service bulletin

No. 98-2

Official Notification Federal Boat Safety Act Over Torque of Flywheel Bolt - 20/25 (2-Stroke) & 20 Jet

1998 20/25 (2-Stroke) & 20 Jet

- a - Washer
- b - Flywheel Bolt
- c - Bolts - M6x35
- d - Bolt (2) M5x20

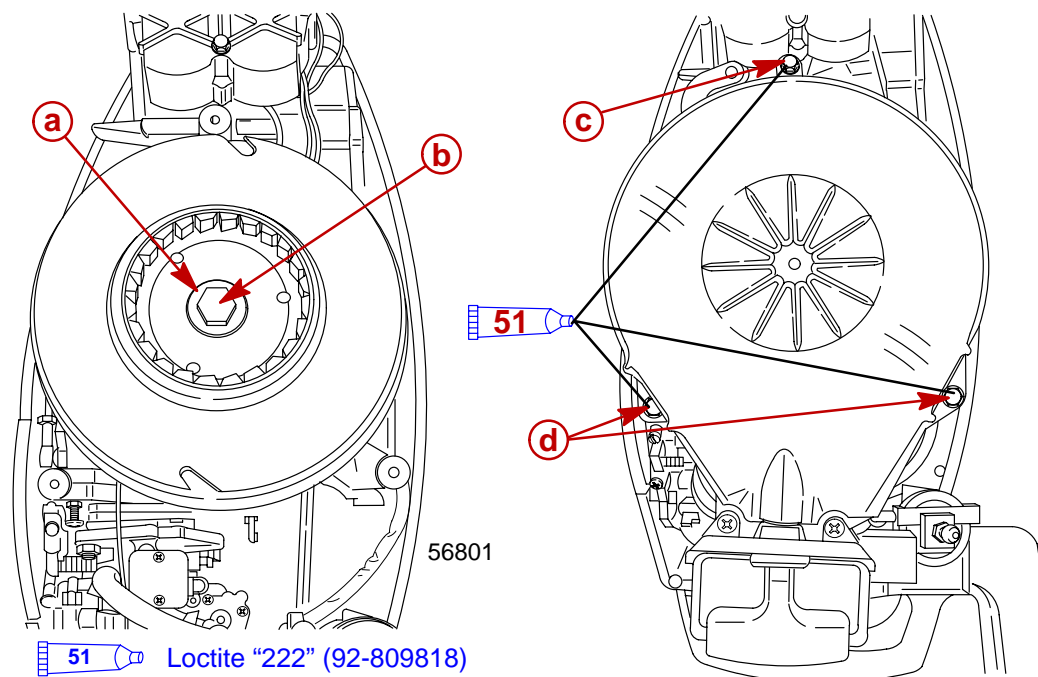
The outboards listed, may have been assembled with a torque level on the flywheel bolt that is too high. The higher torque was caused by a plating change (gold in color changed to gray) on the washer under the flywheel bolt, which reduced the friction under the bolt head. The flywheel bolt could have been over stressed which can cause a fracture, resulting in the possible loss of the flywheel. These units **MUST HAVE** both the flywheel bolt and washer replaced prior to operation.

NOTE: Please mark flywheel bolt torque change where listed in the outboard service manual. New flywheel bolt torque is to be used with either washer.

57.5 lb. ft. (78 N·m)	➔	50 lb. ft. (67.8 N·m)
-----------------------	---	-----------------------

1. Remove manual starter. Remove and discard flywheel bolt and washer.
2. Secure flywheel using new flywheel bolt/new washer. Torque bolt to 50 lb. ft. (67.8 N·m).
3. Re-Install manual starter. Apply Loctite 222 (p/n 92-809818) to threads of (3) mounting bolts and torque bolts to 110 lb. in. (12.4 N·m).
